**La Rosa Pump Station Rehab**  
**Solicitation Number: CO-00314-SM**  
**Job No.: 18-6001**

**ADDENDUM 2**  
**1/30/2020**

SAN ANTONIO WATER SYSTEM  
LA ROSA PUMP STATION REHAB  
**FLOURIDE BUILDING - ELECTRICAL PLAN - PITLUK**

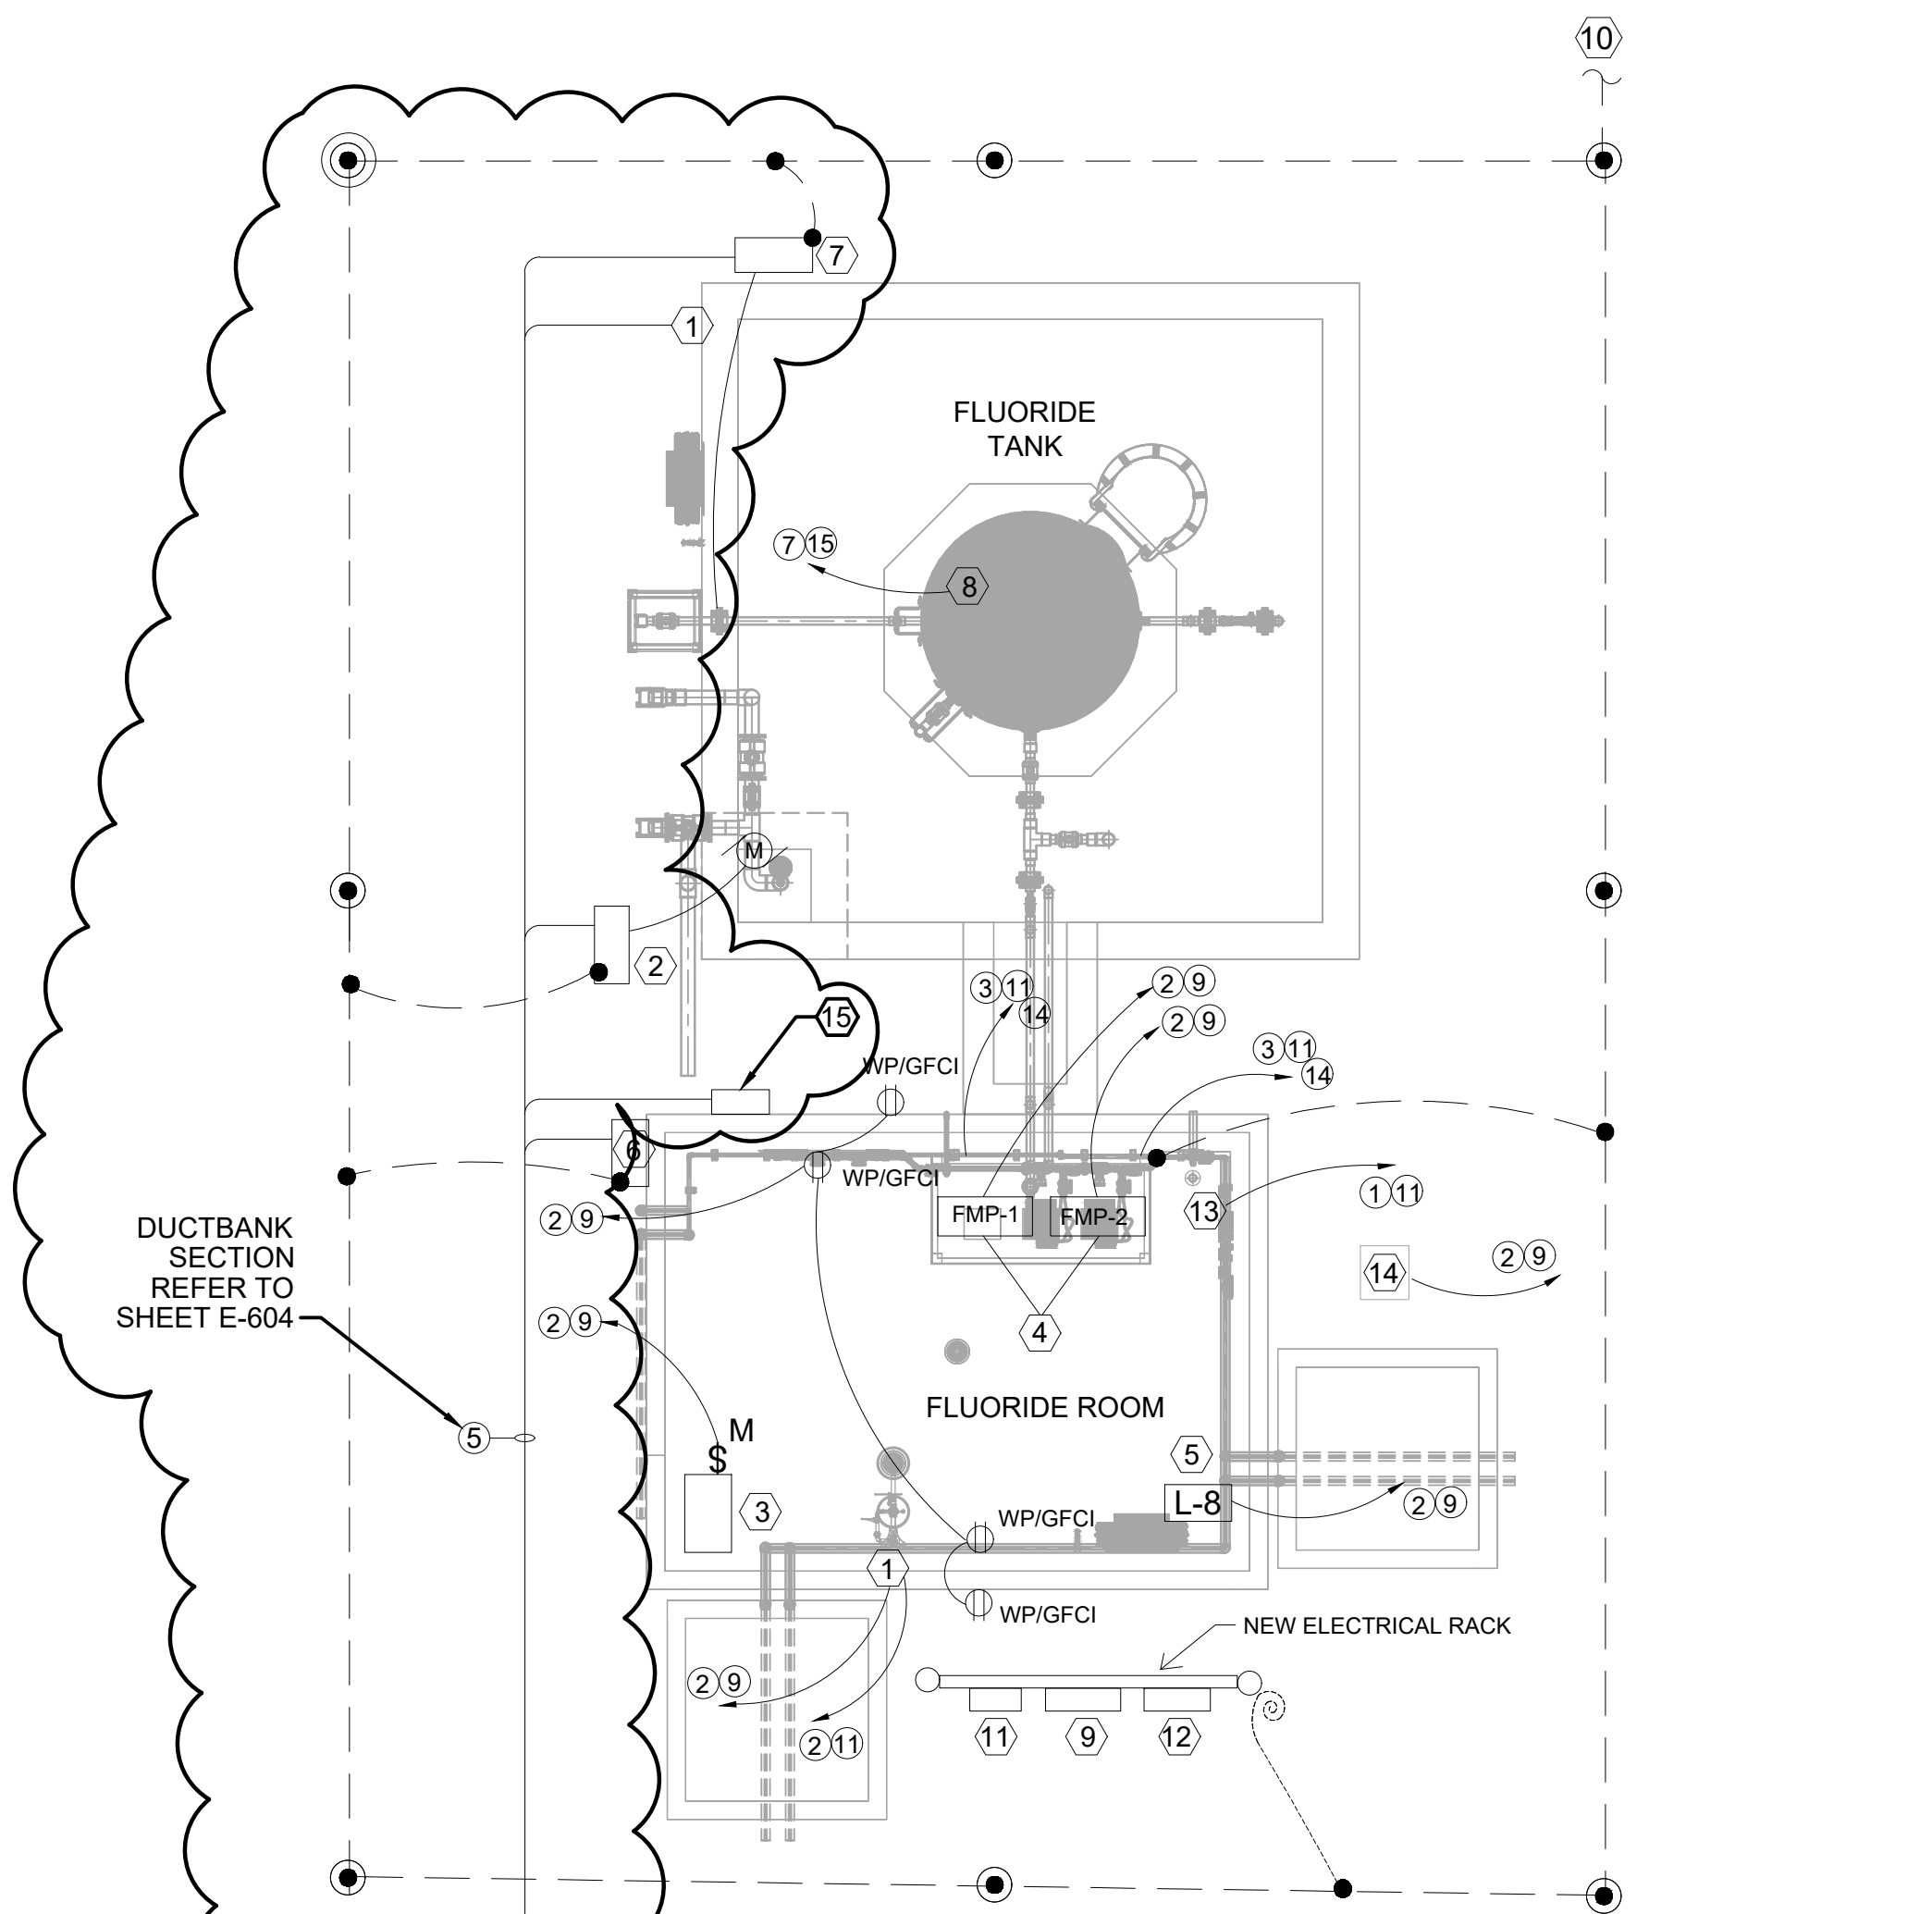
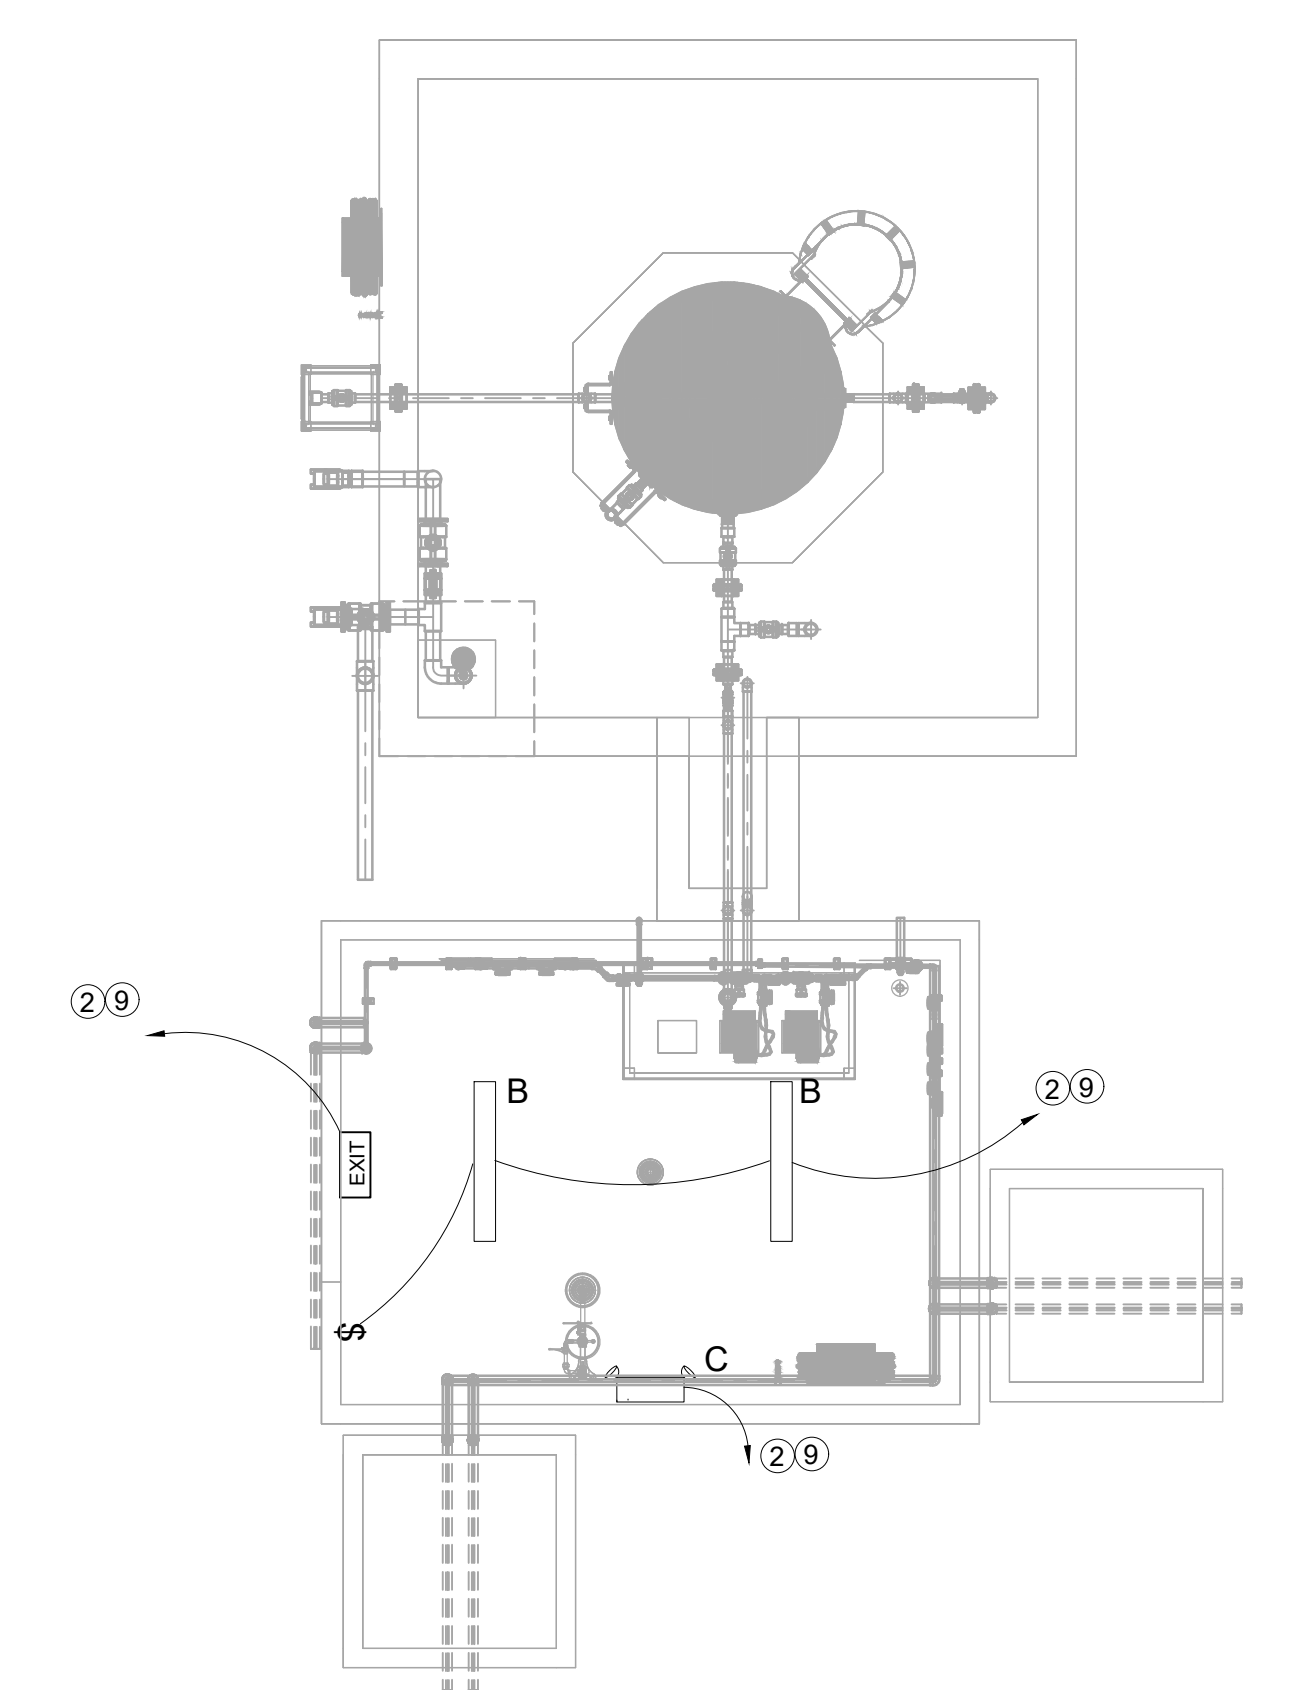
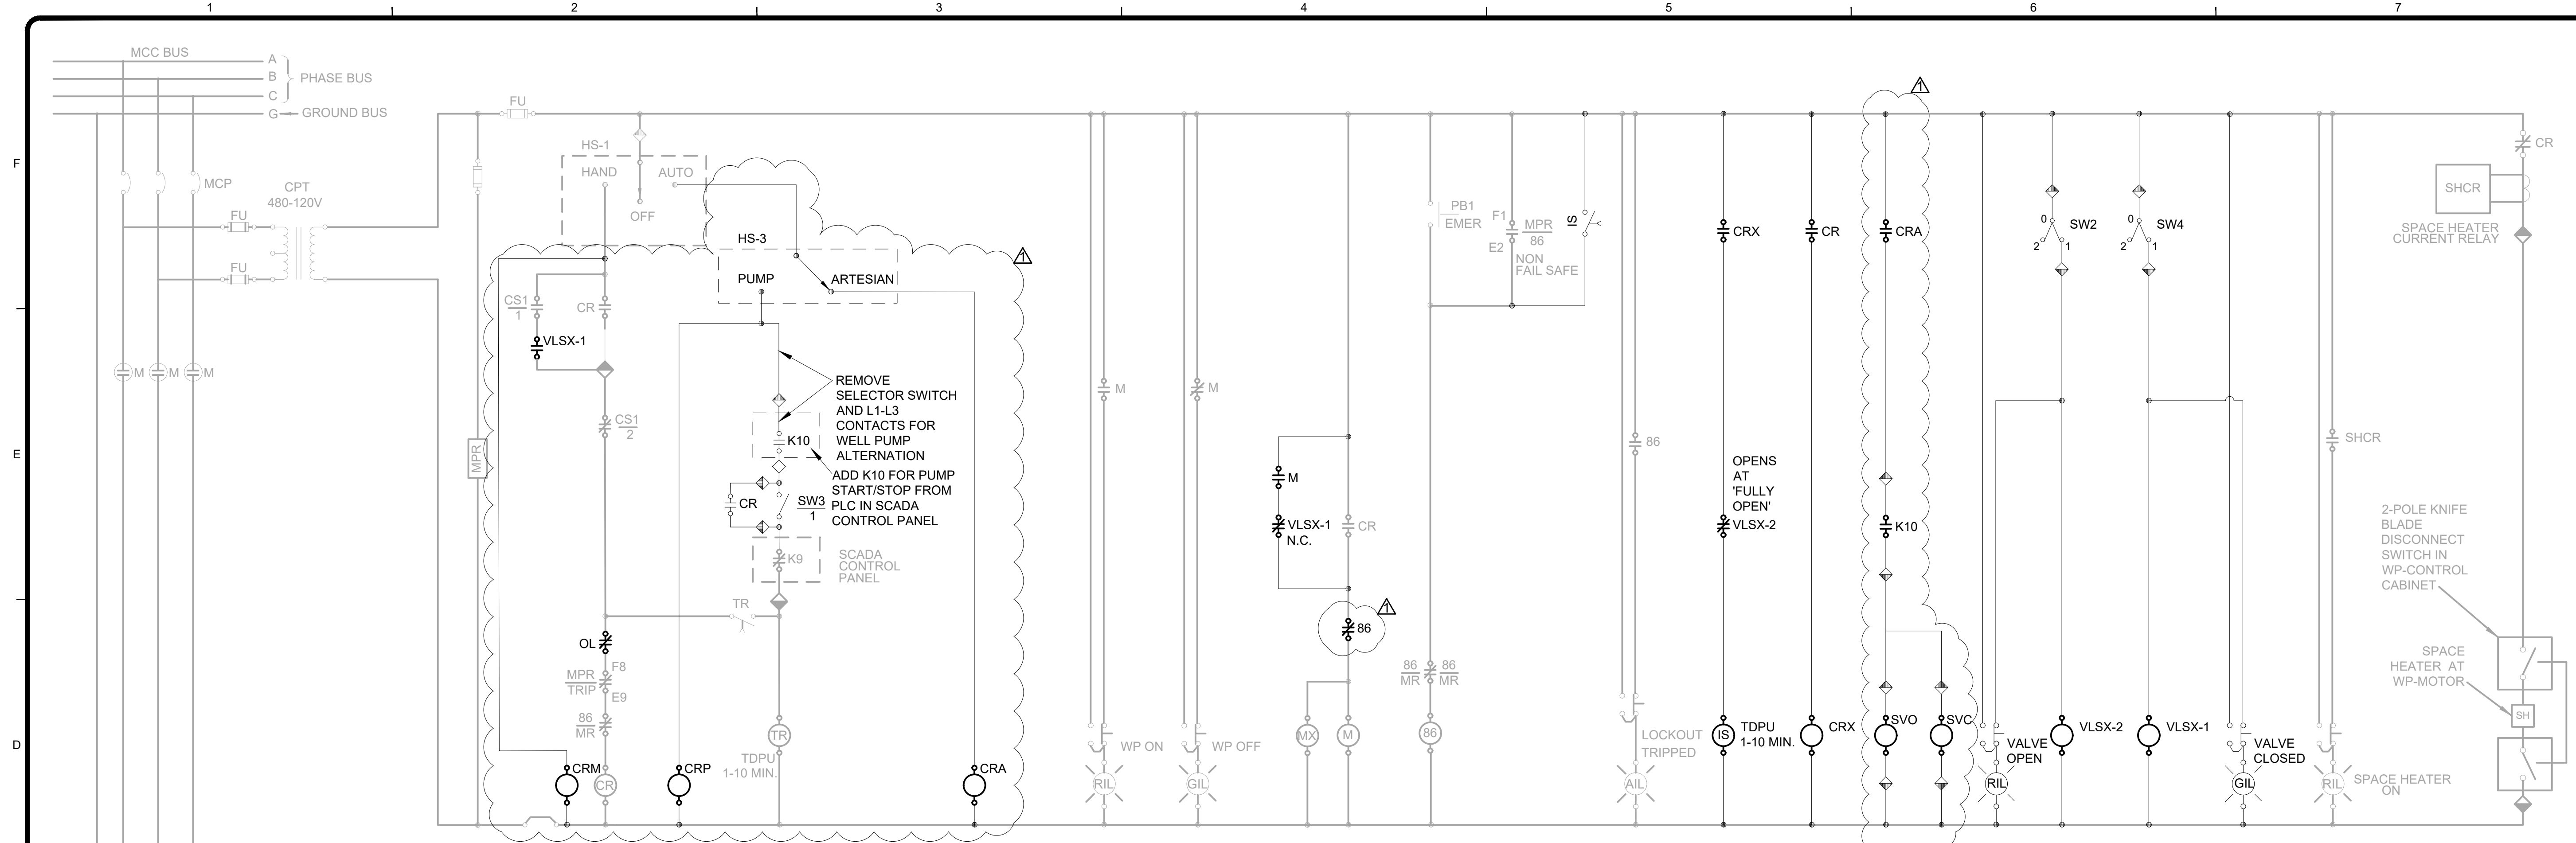
24. Sheet E-402 for Ductbank 1 cables not terminating at the new electrical rack outside the new Fluoride building, but needing to route to Fluoride tank & sump area, is it the intention to split ductbank 1 conduits to another DB? The drawing is not clear between Sheet E-402 and E-405. Please review and clarify.

Response: Yes, a ductbank will be required to extend from the Fluoride building rack to the equipment located at the fluoride tank area. The ductbanks have been added to drawing E-402 and E-405, refer to CHANGES TO THE PLANS of this addendum.
